January 26, 2026

ARCHITECTURAL RESPONSES TO COMMENTS IN THE LAGO FRESCO PROJECT APPEAL BY 'COMMUNITY AGANST LAGO FRESCO'

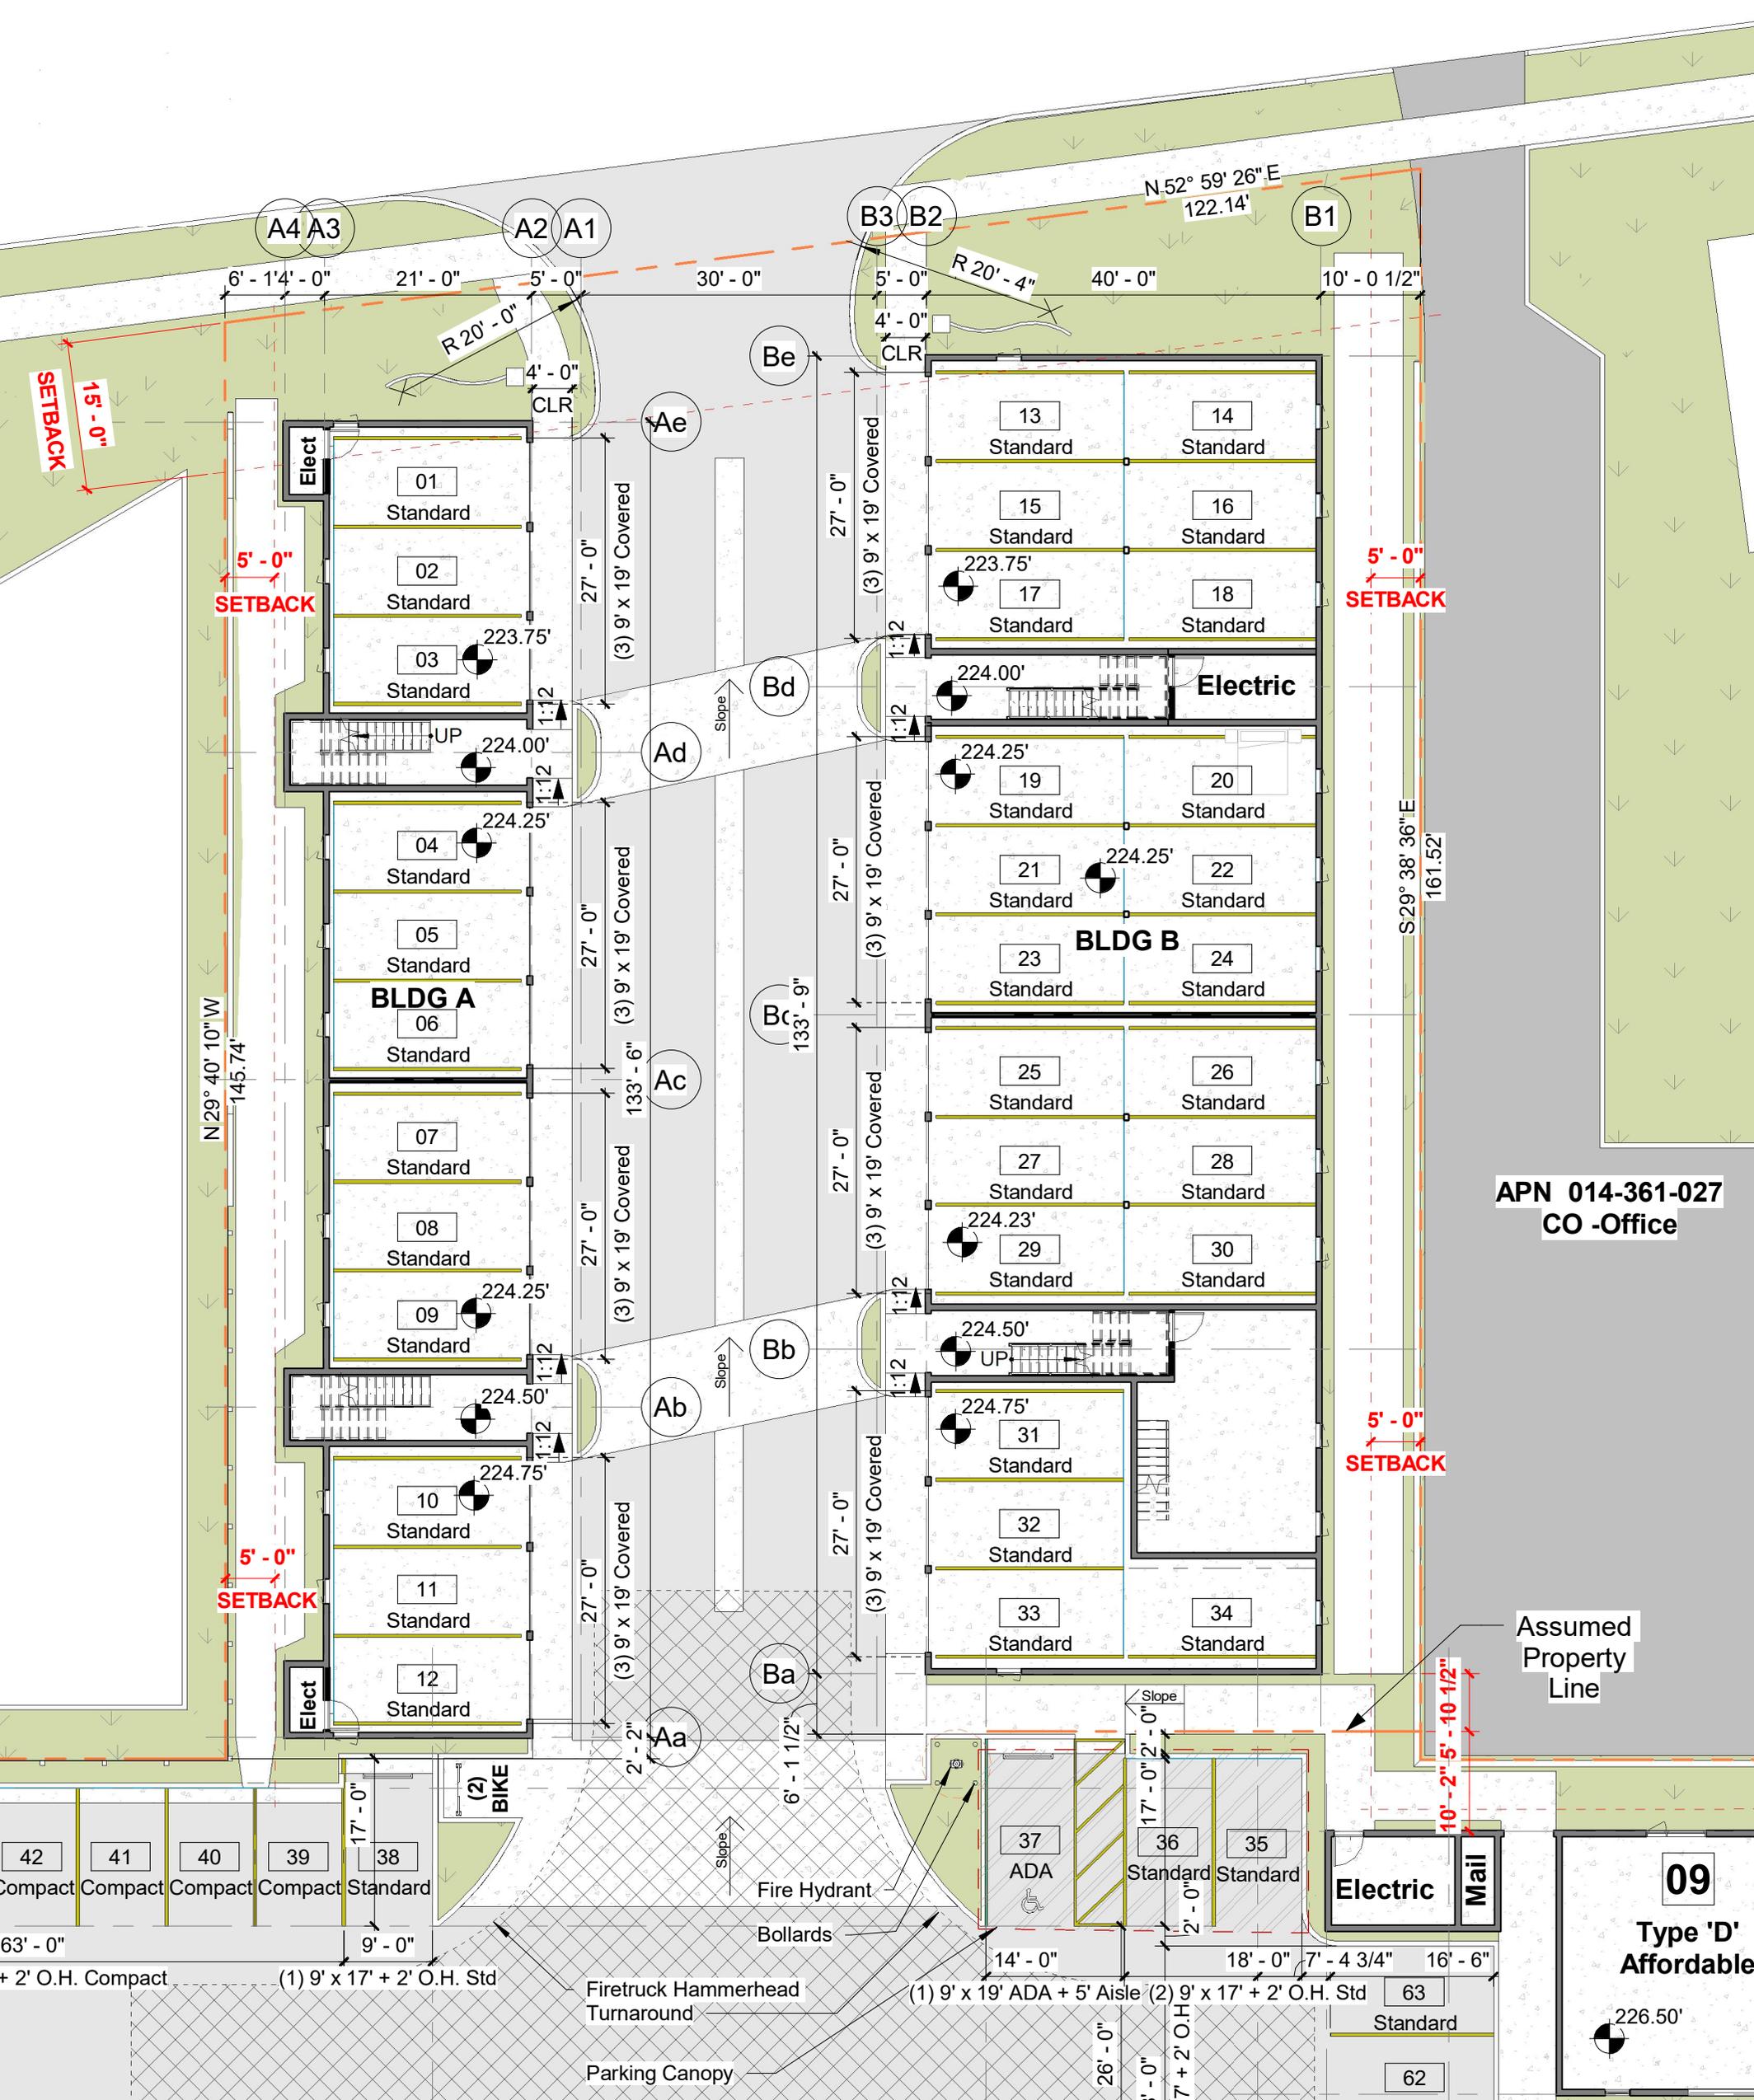
Response to Appeal Comment 4 -

Two 5-foot wide dedicated pedestrian and bicycle paths are provided on both sides of the entry driveway, linking the project facilities to the sidewalk and bike lane on Hoen Avenue. (See attached Enlarged Site Plan Detail).

Response to Appeal Comment 3 -

The project provides one dedicated short term parking on-site parking space, space number 53, for delivery service trucks and other short term parking needs. (See Site Plan, attached).
